Proposed Strategic Housing
Development at the Former
Doyle's Nursery and Garden
Centre and Benoni,
Brennanstown Road,
Cabinteely, Dublin 18.

Quality Audit

Brennanstown Quality Audit

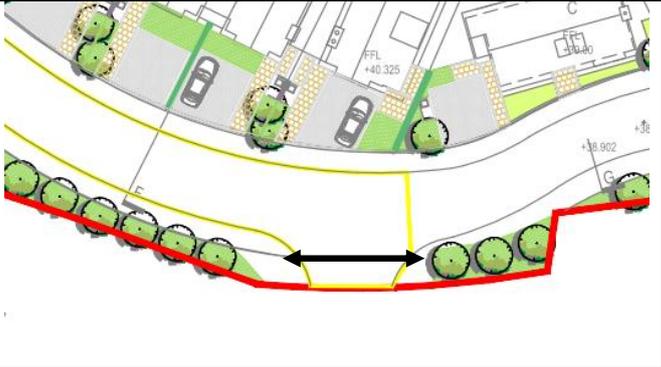
Problem 5.1.1:		
<i>Location</i>	Brennanstown Road/Bray Road Junction	
<i>Drawing</i>	60541707 – SHT – 10-C-0100	
<i>Summary</i>	Lack of crossing facilities	
Description		
<p>There is no tactile paving proposed on the Brennanstown Road arm of the junction. Lack of appropriate crossing facilities creates a barrier for pedestrians at the junction, in particular, for visually impaired pedestrians who may not be aware there is a crossing location at this location.</p>		
Recommendation:		
<p>Tactile paving and dropped kerbing should be provided to allow pedestrians to cross safely.</p>

Section 1 – Issues relating to proposed Brennanstown Road Upgrade (footpath on the western side of the road)				
Paragraph No. in Safety Audit Report	Problem Accepted (yes/no)	Recommendation accepted (yes/no)	Alternative measures (describe)	Auditor's Accepted Measure
5.1.1 Brennanstown Road / Bray Road Junction Tactile paving and dropped kerbing should be provided to allow pedestrians to cross safely.	Yes	Yes – tactile paving and dropped kerbs have been introduced 60541707-SHT-10-C-0100_RevB		Yes
5.1.2 Brennanstown Road at Carrig Glen Junction Appropriate crossing facilities should be provided for pedestrians through the junction	Yes	Yes - Tactile paving has been provided on the northern arm of Brennanstown Road. See AECOM drawing no. 60541707-SHT-10-C-0101.		Yes

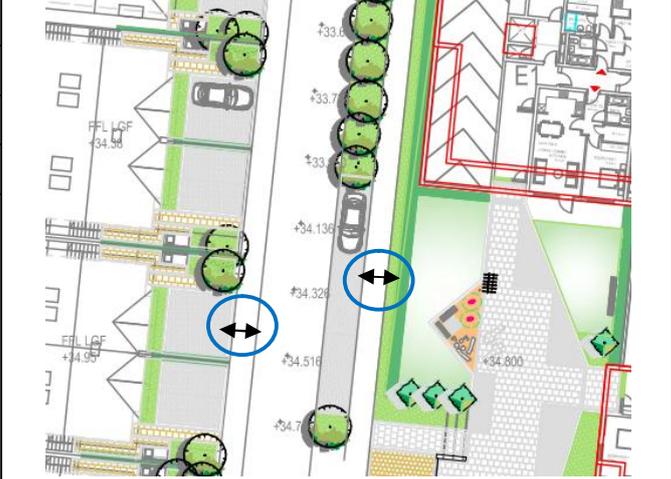
Problem 5.1.3:		
<i>Location</i>	Roundabout at access to development	
<i>Drawing</i>	60541707 – SHT – 10-C-0100	
<i>Summary</i>	Tactile Paving off Desire Line	
Description		
<p>The tactile paving located on the Lambourne Wood arm of the roundabout appears to be off the desire line for pedestrians crossing. This could lead to pedestrians crossing where no crossing exists and could also cause confusion for visually impaired pedestrians.</p> <p>In addition, tactile paving has not been provided on the development arm or the southern arm of the roundabout.</p>		
Recommendation:		
<p>Tactile paving should be provided at all crossing locations, on the desire line.</p>

<p>5.1.3 Roundabout at access to development</p> <p>Tactile paving should be provided at all crossing locations, on the desire line.</p>	<p>Yes</p>	<p>Yes – Tactile paving now provided at all crossing locations. Please refer to AECOM drawing no. 60541707-SHT-10-C-0101.</p>		<p>Yes</p>
<p>5.1.4 Throughout Brennanstown Road</p> <p>The footpath provided is narrow over the majority of Brennanstown Road and does not meet the recommended minimum width of 1.8m as per DMURS Guidance Document. Provision of a narrow footpath could cause pedestrians to veer into the road carriageway due to lack of space which could cause a collision with a vehicle.</p>	<p>Yes</p>	<p>Yes – Footpath width is 1.8m wide where possible, as per Section 4.3.1 of the Design Manual for Urban Roads and Streets (DMURS). However due to constraints in the Brennanstown Road carriageway width, the footpath width reduces to less than 1.8m for a distance of approx. 30m. Please refer to AECOM drawing no. 60541707-SHT-10-C-0101.</p>		<p>Yes</p>

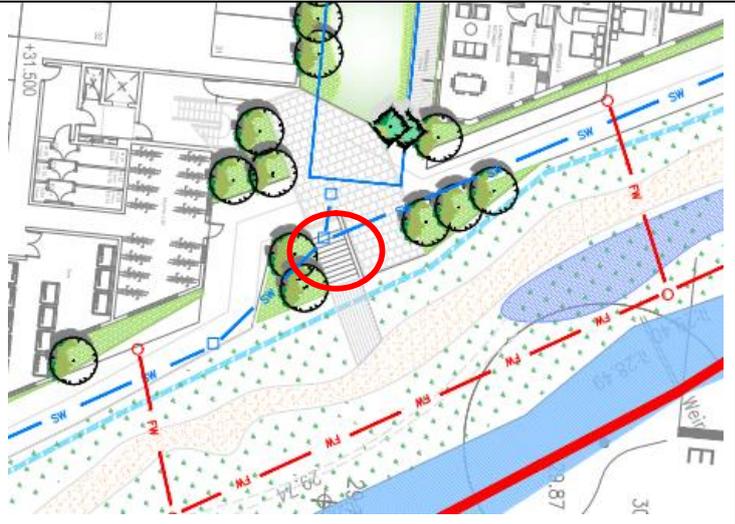
Problem 5.1.4:		
<i>Location</i>	Throughout Brennanstown Road	
<i>Drawing</i>	60541707 – SHT – 10-C-0100	
<i>Summary</i>	Narrow Footpath	
Description		<p>The footpath provided is narrow over the majority of Brennanstown Road and does not meet the recommended minimum width of 1.8m as per DMURS Guidance Document. Provision of a narrow footpath could cause pedestrians to veer into the road carriageway due to lack of space which could cause a collision with a vehicle.</p>

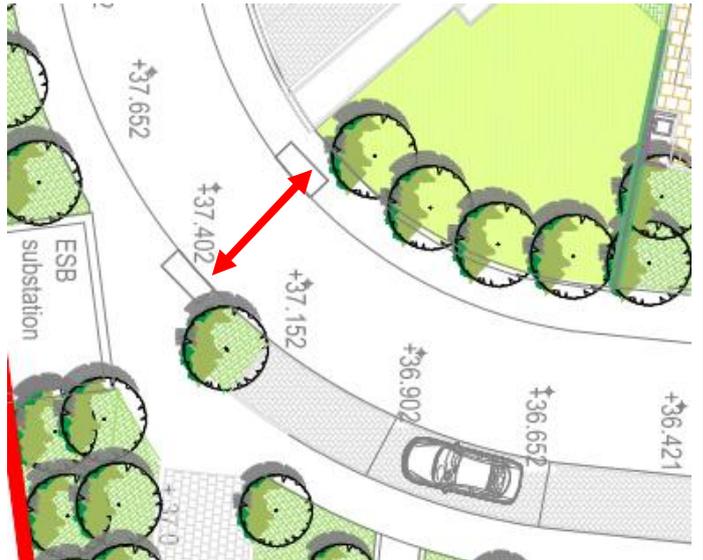
Problem 5.2.1:		
<i>Location</i>	Internal Development Road	
<i>Drawing</i>	1395 – 4070	
<i>Summary</i>	No Crossing Facilities	
Description		
<p>It is unclear what the access on the southern side of the access road provides access to and the volume of traffic that will use it. There are no crossing facilities provided for pedestrians across this access arm. Lack of crossing facilities creates a barrier for vulnerable road users.</p>		
Recommendation:		
<p>Dropped kerbs and tactile paving should be provided as appropriate.</p>

Paragraph No. in Safety Audit Report	Problem Accepted (yes/no)	Recommendation accepted (yes/no)	Alternative measures (describe)	Auditor's Accepted Measure
<p>5.2.1 Internal Development Road</p> <p>Dropped kerbs and tactile paving should be provided as appropriate.</p>	Yes	Yes - Dropped kerbs and tactile paving have been included within the proposed layout in accordance with the Traffic Management Guidelines (Department of Environment and Local Government).		Yes
<p>5.2.2 Internal Development Road</p> <p>Ramps should be provided as appropriate in this location to provide access for mobility impaired users.</p>	No		<p>A pedestrian ramp is located immediately south of the steps, which provides access for mobility impaired persons.</p> <p>The ramp connects to a lift which facilitates access to the basement level. Please refer to the submitted landscape drawings.</p>	Yes
<p>5.2.3 Basement Car Park</p> <p>Disabled parking bays in the basement car park should be located close to the lifts/stairwells in each building.</p>	Yes	Please refer to the architects revised basement layout which illustrates disabled parking in locations prominent to the lifts / stairwells.		Yes

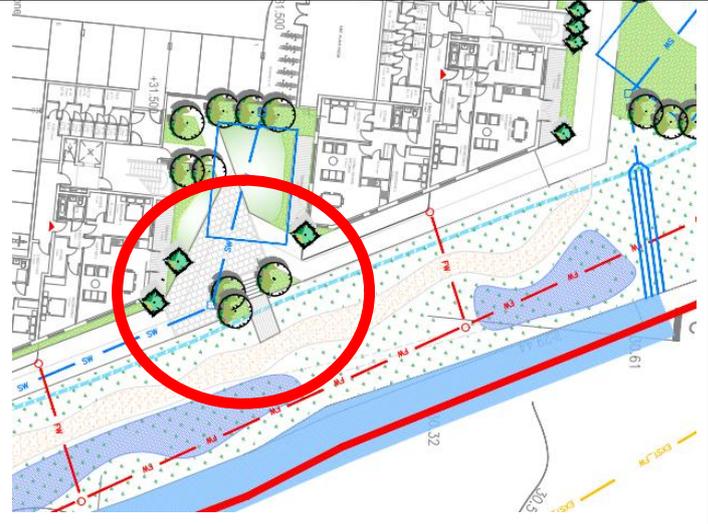
Problem 5.2.4:		
<i>Location</i>	Throughout Internal Roads	
<i>Drawing</i>	1395 - 4070	
<i>Summary</i>	Narrow Footpath	
Description		
<p>The footpath proposed appears narrow in sections along the internal roads of the development. Provision of a narrow footpath could cause pedestrians to veer into the road due to lack of space which could cause a collision with a vehicle.</p>		
Recommendation:		
<p>A footpath width of 2.0m should be provided in accordance with the National Disability Authority's Building for Everyone.</p>

<p>5.2.4 Throughout Internal Roads</p> <p>A footpath of 2.0m should be provided in accordance with the National Disability Authority's Building for Everyone.</p>	Yes		Yes - A footpath width of 1.8m (min) has been provided in accordance with the Design Manual for Urban Roads and Streets (DMURS). See AECOM drawing no. 60541707-SHT-10-C-	Yes
